# Errata

## SLG46169

### CE-GP-020

*This document contains the known errata for SLG46169 and the recommended workarounds.*

### 3.1 Long RC OSC Settling Time

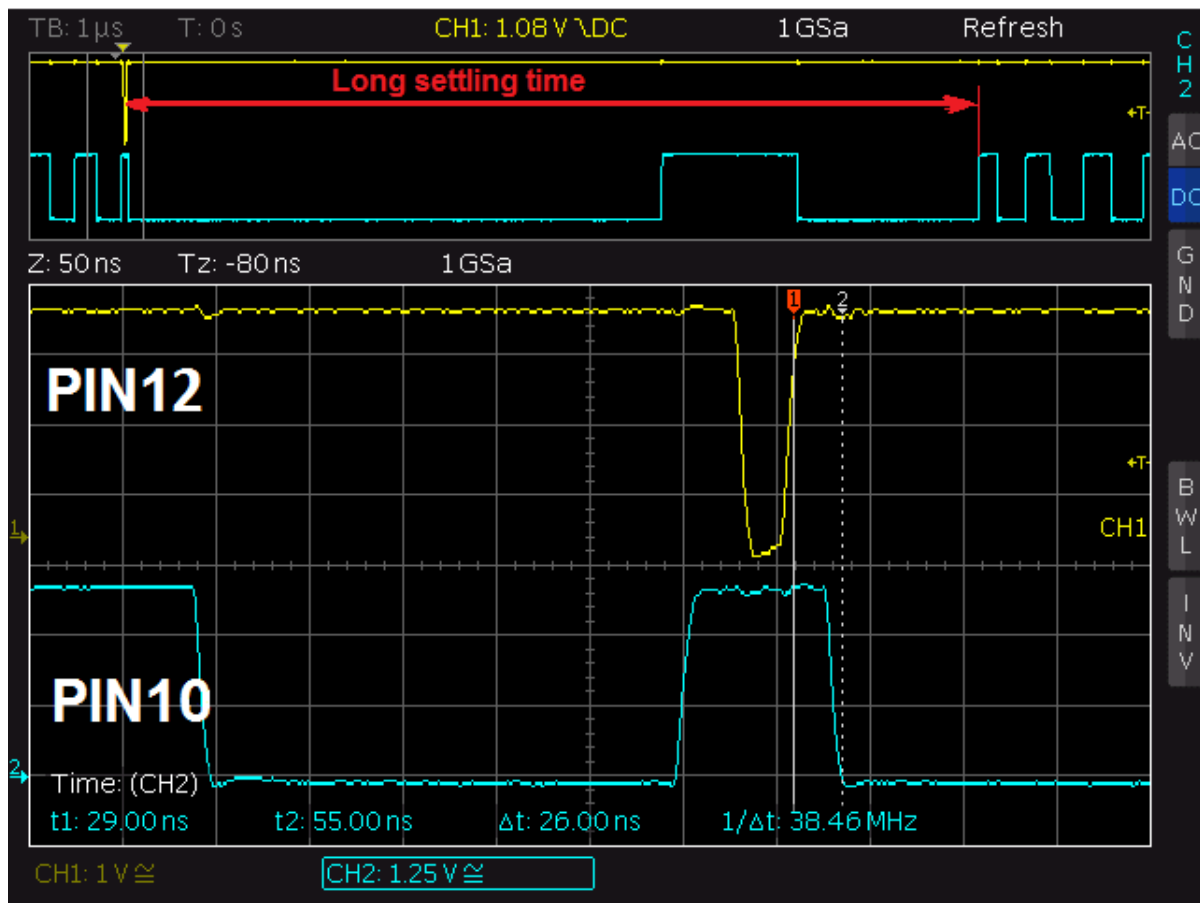
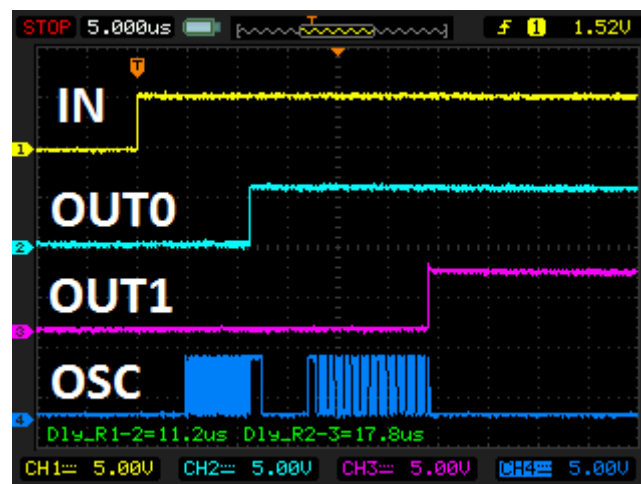
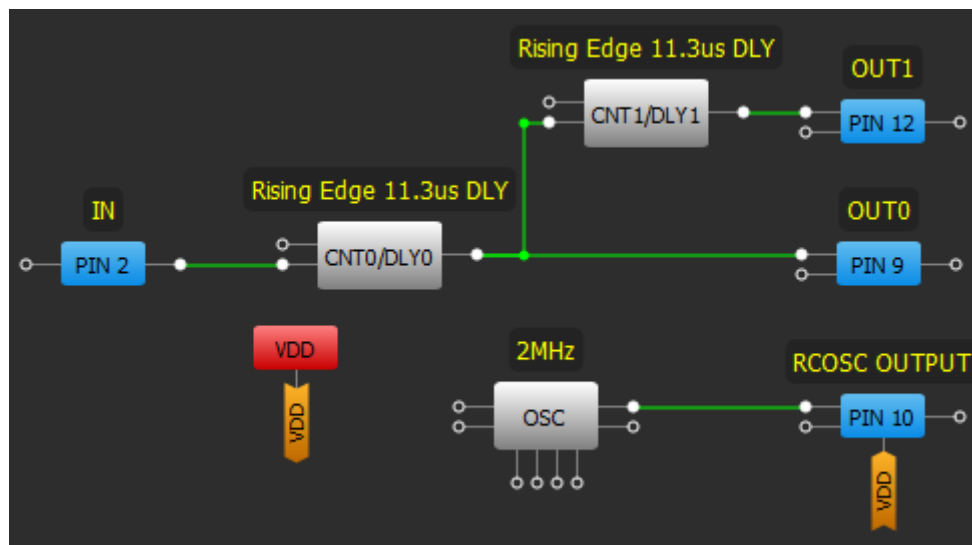
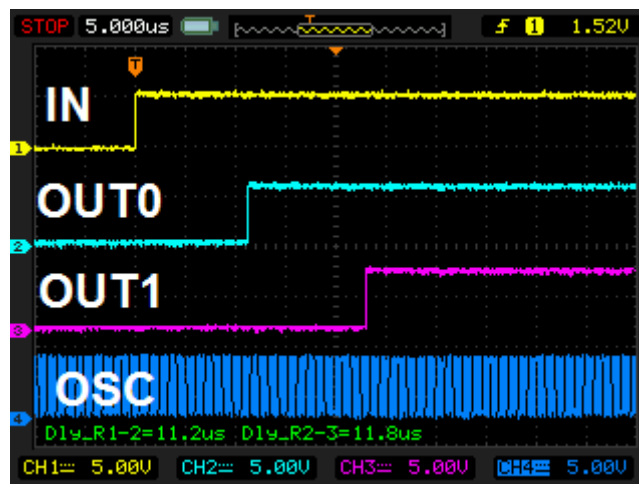
The RC OSC has a longer settling time when configured as 2 MHz with Auto Power On in the designs that have very short RC OSC disable time.

The configuration shown above generates a periodical signal with a frequency defined by the Delay cell and started by a HIGH signal on PIN2. The issue becomes apparent in a longer settling time when the scheme generates short pulses (Delay is configured as a rising edge delay only). See waveform below.

Such behavior will lead to substantial error in period calculations if the delay time is relatively small.

The same situation occurs while using two connected delays (all edge detect types except for a pair “Rising edge DLY – Falling edge DLY”).

In the following example, Delay0 and Delay1 are configured in the same way. However, Delay1 time is 17.8 us instead of expected 11.3 us (Delay0 time).

- In first case use block with longer propagation time.

- using two delays in series (except for a pair “Rising edge DLY – Falling edge DLY”) use one Filter cell or P DLY between delay blocks. Using LUTs won't help in this case.

- use the “Force power on” RC OSC power control option to make the RC OSC operate at all times.

### 3.2 LATCH Block nRESET Incorrect Operation

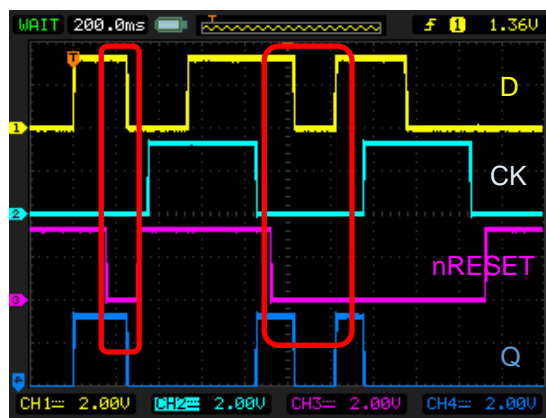
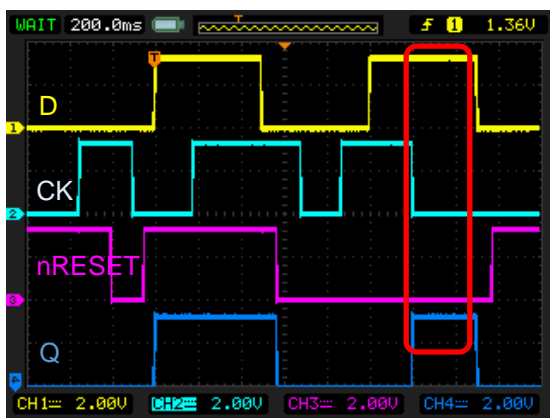
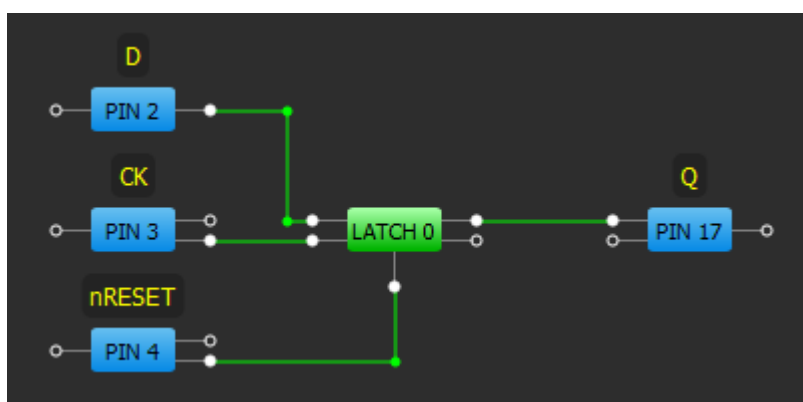
The reset function in LATCH blocks does not operate correctly. This can be described as function failure when nRESET input is set LOW.

The scope shots shown above show the incorrect nRESET function operation marked with red rectangles. From these waveforms can be seen that the reset function operates only when the CK signal is HIGH, in all other cases it is inoperational.

- Avoid using nRESET function in LATCH blocks in SLG46721/722 devices, if possible, use SLG46110/120 devices, where this function operates correctly.
- Use nSET configuration, initial state HIGH, add inverter on D input and use nQ (inverted) output of the LATCH block:

### 3.3 Glitches on ACMP Output

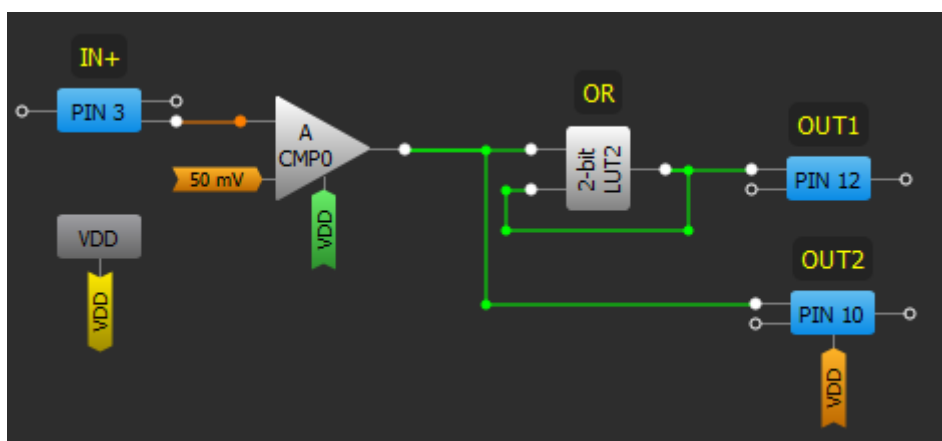
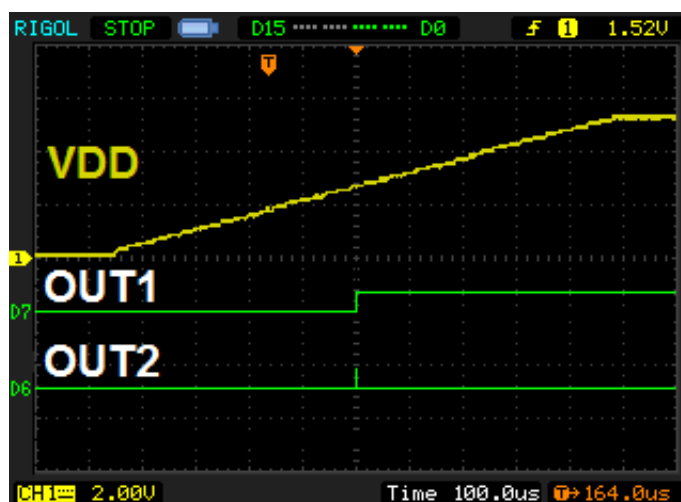
In some cases, ACMP may have short high-level glitches on its output (even if IN+ voltage is less than IN- voltage) after GreenPAK chip being powered up. Such cases may appear when using ACMP with Low Bandwidth mode enabled and Power Up is connected directly to the V<sub>DD</sub>.

In order to detect such glitches, scheme with additional LUT was used. This LUT detects high level on ACMP output and stays high until chip powers down.

Use POR block, connected to the ACMP's Power-Up pin. However, in this case ACMP will start working with low level output and will be able to go high only after POR goes high + ACMP power on time.

### 3.4 Delay Lock-up by a Short Pulse

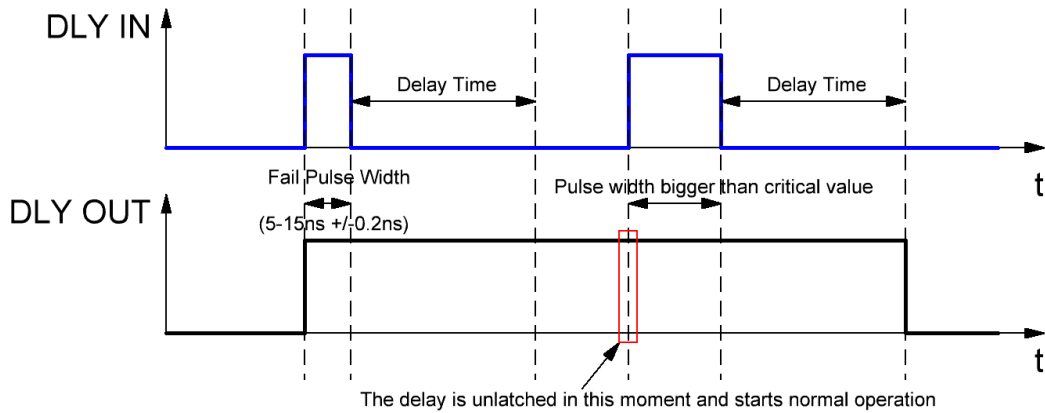
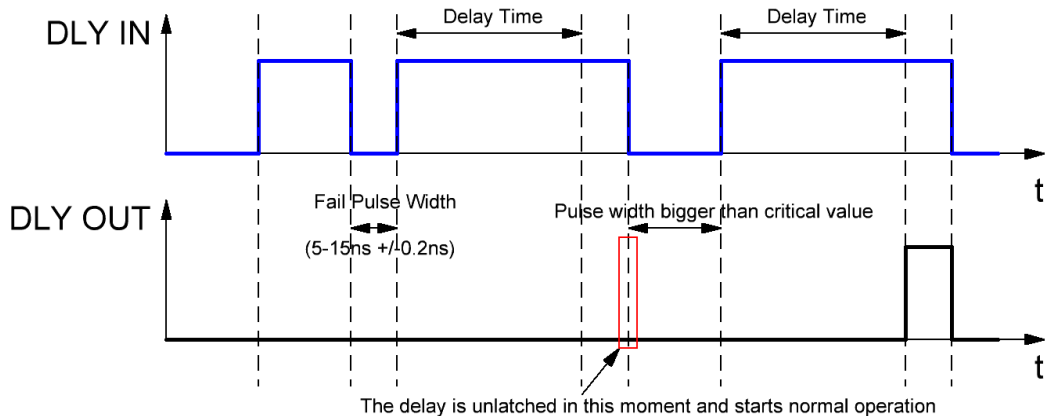
The delay output could be latched despite the input change when a short pulse is input. For example, if the delay cell is configured as a falling edge delay, the short pulse (see NOTE) appears on its input the delay cell output will switch from LOW to HIGH but may not switch from HIGH to LOW even after the delay time has passed.

NOTE: The pulse width varies from chip to chip and with different  $V_{DD}$  voltage. It is in range of 5-15 ns and in the window  $\pm 0.2$  ns, so it should be very precise for issue happen.

Also, note that both edge delays do not have such issue.

Use P DLY/FILTER block configured as a both edge delay or FILTER.

## 3.6 FILTER Cell does not Filter Out Glitches

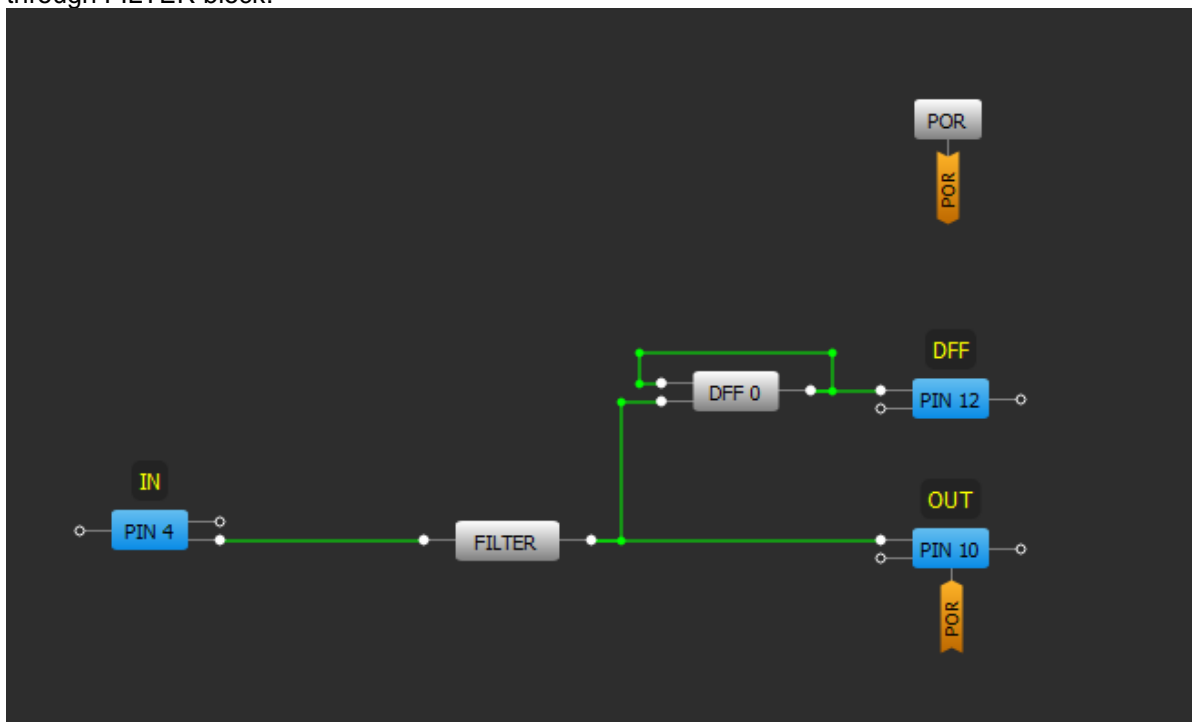
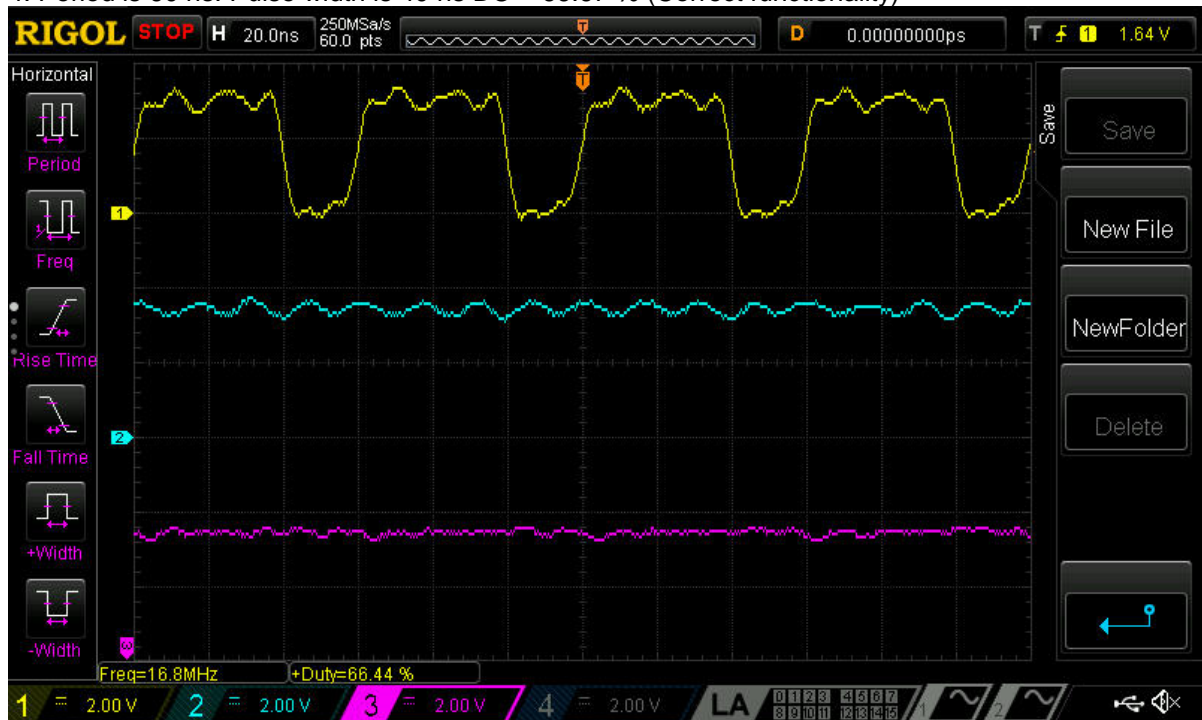
If clock type high frequency input comes in, the FILTER cell may not filter out it. There are several factors like input frequency, duty cycle and LOW duration in such signal that may lead to its passing through FILTER block.

1. Period is 60 ns. Pulse width is 10 ns DC = 16.7 % (Correct functionality)

2. Period is 60 ns. Pulse width is 20 ns DC = 33.3 % (Incorrect functionality)

3. Period is 60 ns. Pulse width is 30 ns DC = 50 % (Incorrect functionality)

4. Period is 60 ns. Pulse width is 40 ns DC = 66.67 % (Correct functionality)

Currently there is no workaround for this issue. Filter block is good at filtering short spontaneous glitches. It is intended to be used in series connection before the delay cell to avoid its latching (see issue #5).

### 3.7 Extra Short RC OSC Settling Time

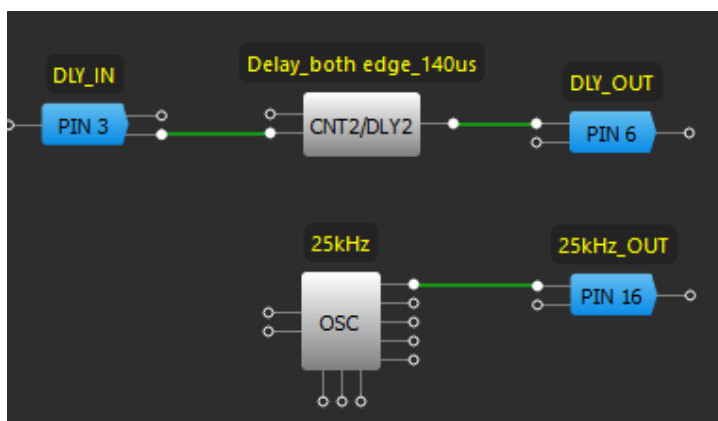
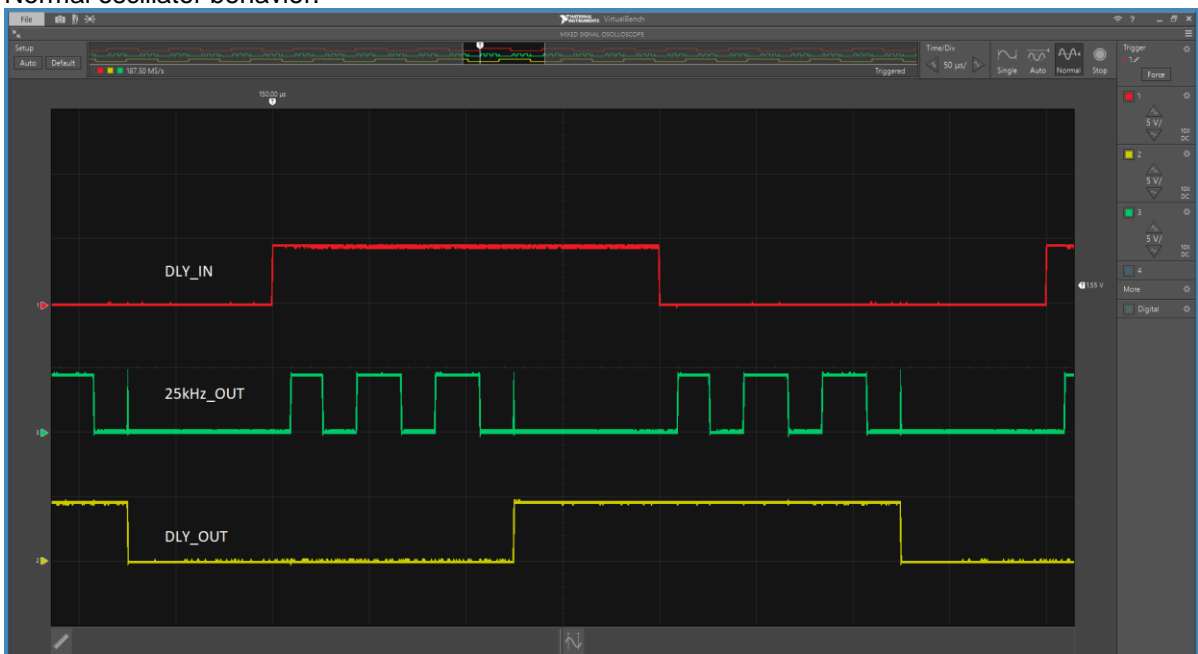
The first period of the RC OSC can be very short when OSC configured as 25 kHz with Auto Power On in the designs. This can occur when  $V_{DD}$  is above 4.0 V. Critical for CNT/DLY with a low counter data (less than 10) or if it is necessary to use the frequency of the OSC to clock external elements. An example of such issue is in the following configuration:

Normal oscillator behavior.

Abnormal oscillator behavior.

- Avoid  $V_{DD}$  higher than 4 V
- Force ON OSC
